ADA Curb Ramp New Construction Inspection Form (Blended Transition)

NW MAIN ST

24953

NW NORTH AVE

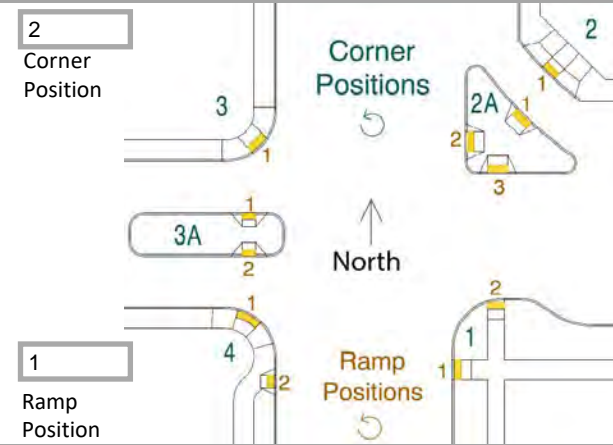
Large crack through gutter and curb
